CLEARWAY, LOT 5

STORM SEWER NOTES AND DETAILS

EL PASO COUNTY FILE NO. PCD # PPR-22-034

# Roadway Plans\_V2 redlines.pdf Markup Summary

STORM 5,6 - OUTFALL RIPRAP  
APRON W/HEADWALL SECTION (TYP.)

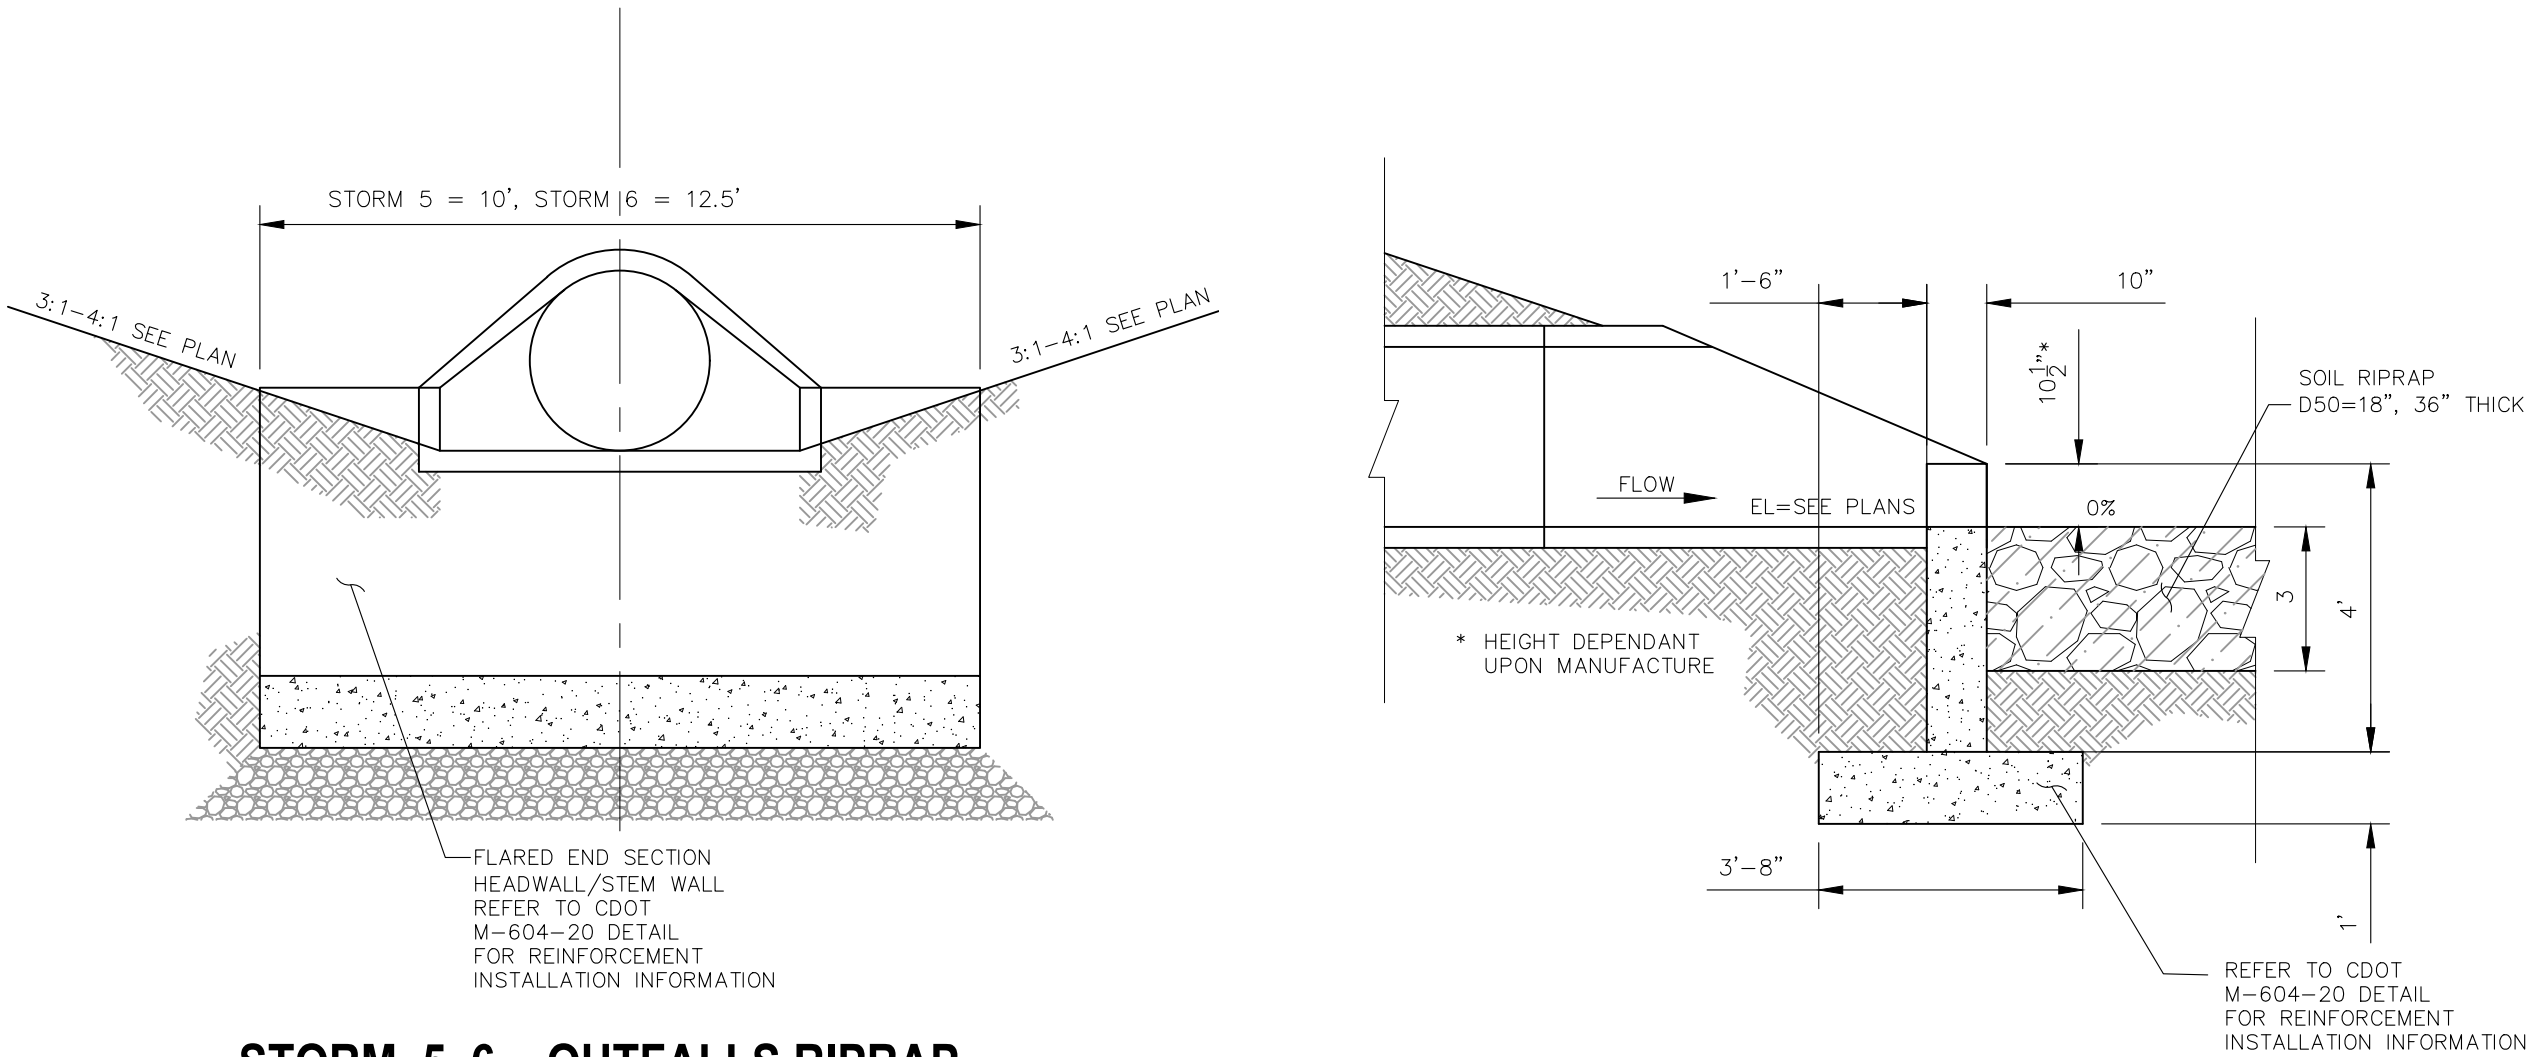
review 1: identify the  
cut-off wall indicated  
in the GEC plan  
review 2: unresolved.  
Please identify the  
cutoff wall and  
reference the detail  
on the next page

review 1: identify the cut-off wall indicated in the GEC plan  
review 2: unresolved. Please identify the cutoff wall and reference the detail on the next page

Cut off wall  
note added

ST08  
SHEET 13 OF 16

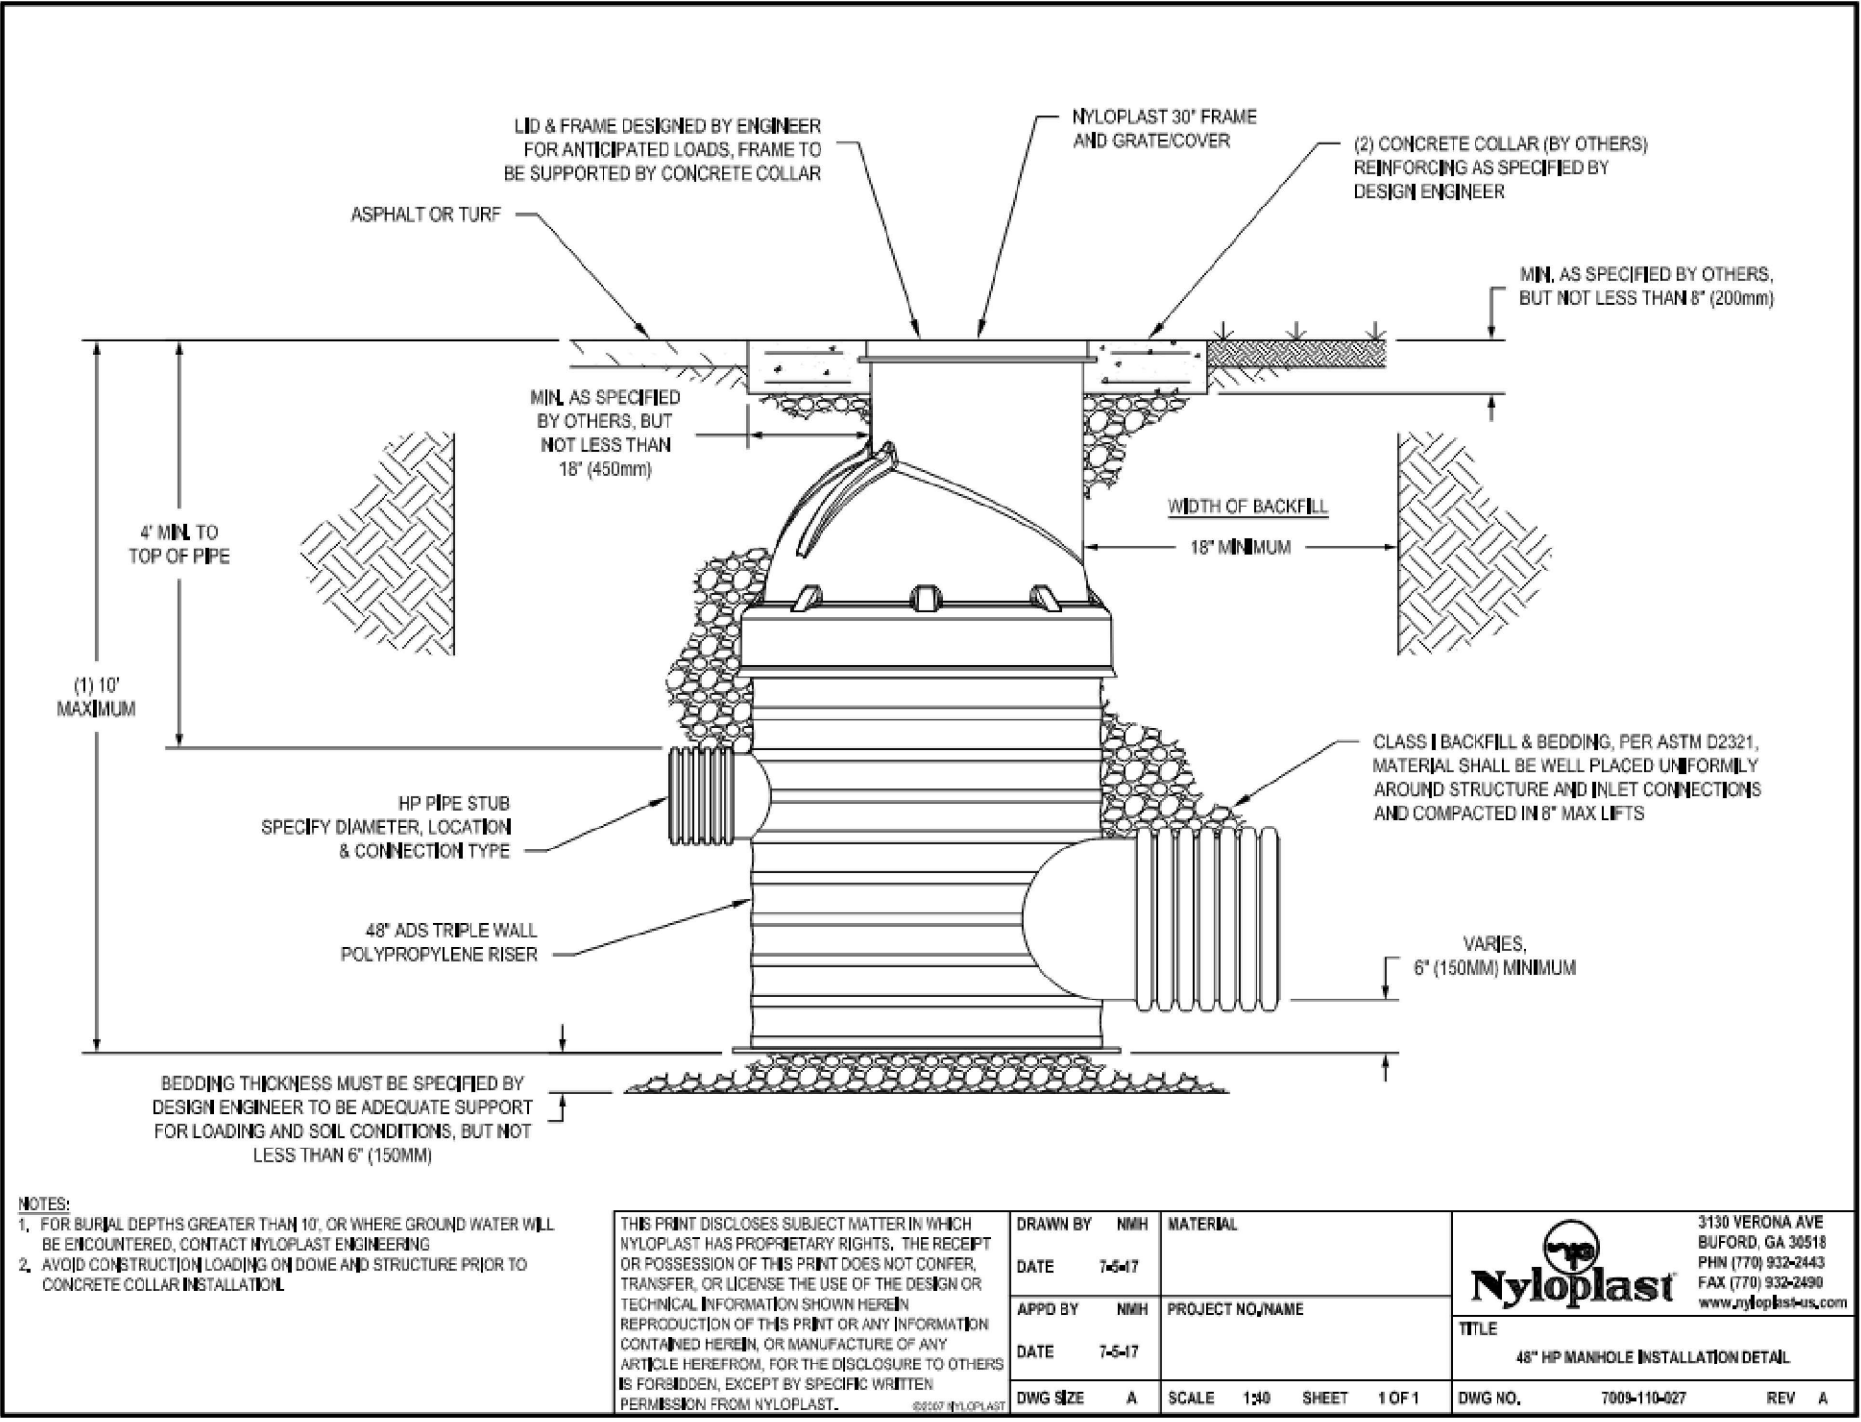
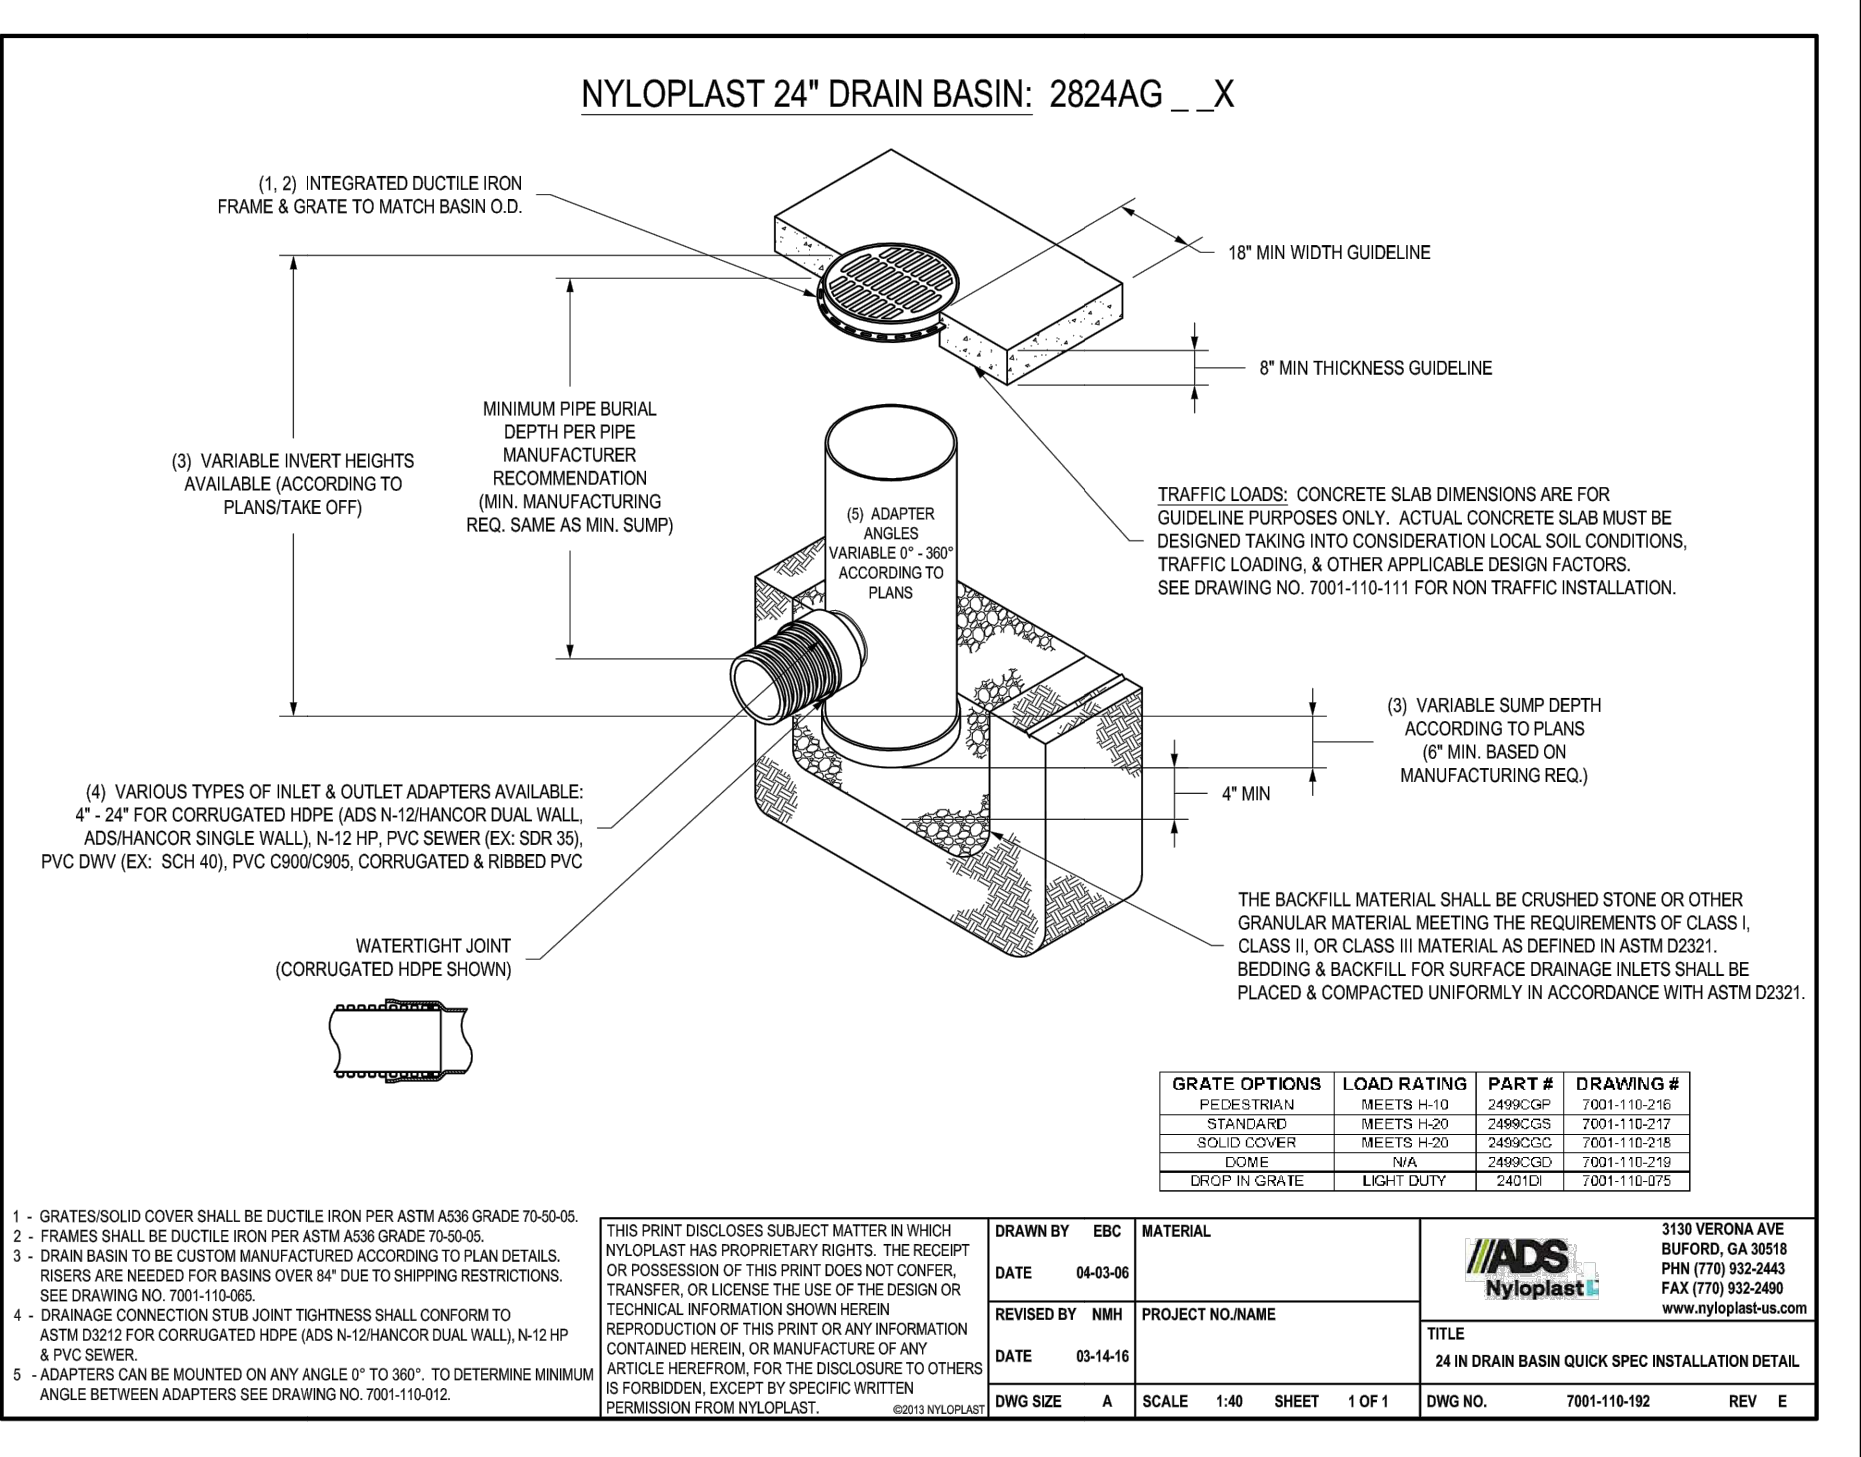
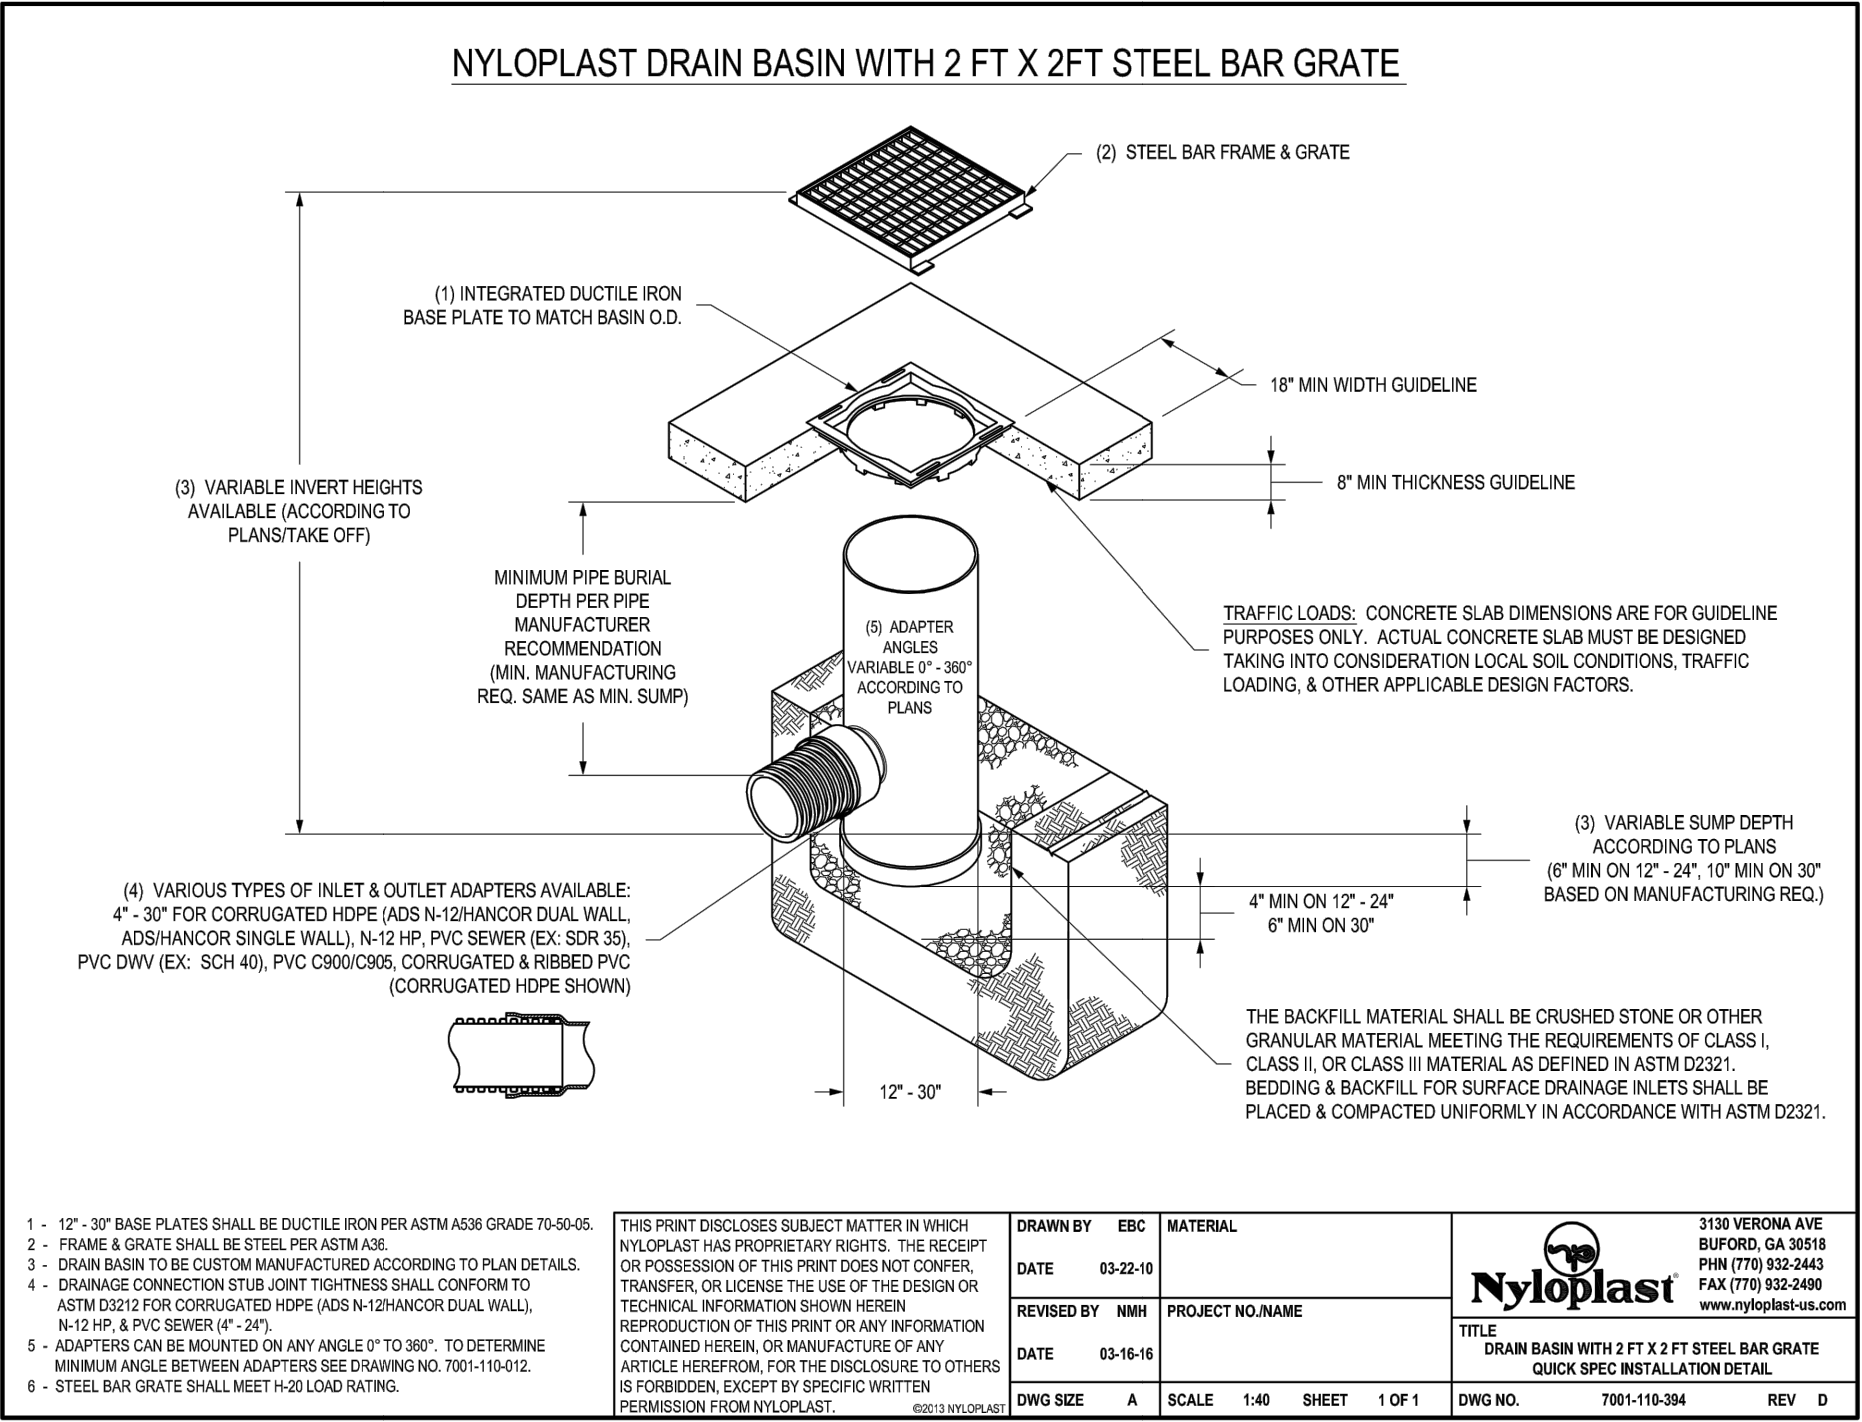
a 2"x 2.5" is identified in the design calculation. Revise accordingly so that they are consistent with each other
